**From:** [Carol Horton](#)  
**To:** [LucerneSolar@blm.gov](mailto:LucerneSolar@blm.gov)  
**Cc:** [Robyn C. Purchia](#); [Gregory\\_Thomsen@blm.gov](mailto:Gregory_Thomsen@blm.gov)  
**Subject:** ABJC Comments on DEIS for Lucerne Valley Solar Project  
**Date:** 05/20/2010 04:24 PM  
**Attachments:** [2422-010d ABJC Comments on DEIS 5-20-10.pdf](#)

May 20, 2010

Re: Draft Environmental Impact Statement for Lucerne Valley Solar Project

*Exhibit 3*  
*Alternative Site Plan 1*

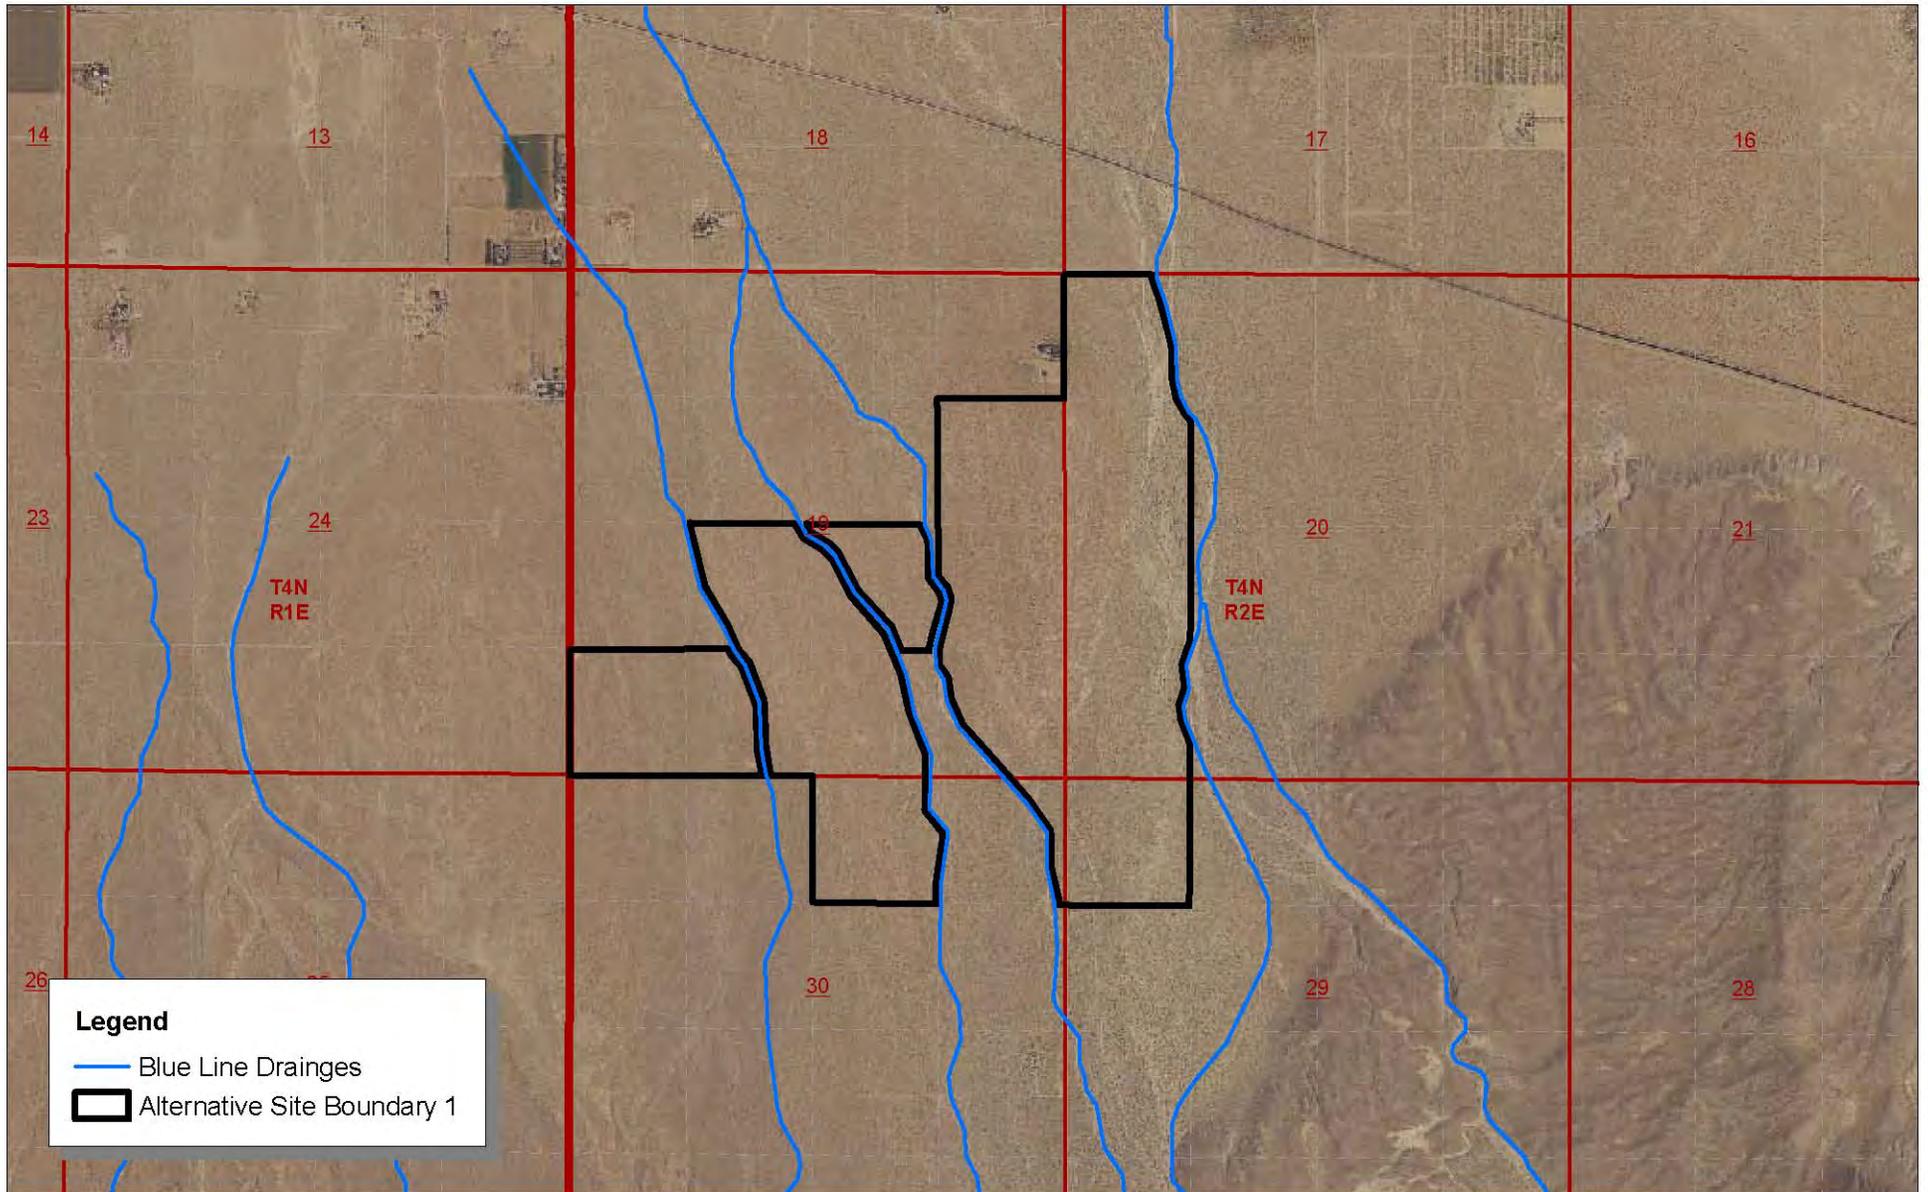
To mitigate impacts associated with runoff water, the BLM should require the Applicant to plant native emergent vegetation in locations where the flows will exit the Project site.<sup>134</sup> Native plants around the drainage outlet locations would provide beneficial cover and refugia for wildlife species.<sup>135</sup> The BLM should also require the Applicant to implement bioswales and/or catchment basins.<sup>136</sup> Bioswales and catchment basins could remove silt and pollution from surface runoff water, as well as provide another source of refugia, cover and food for wildlife.<sup>137</sup>
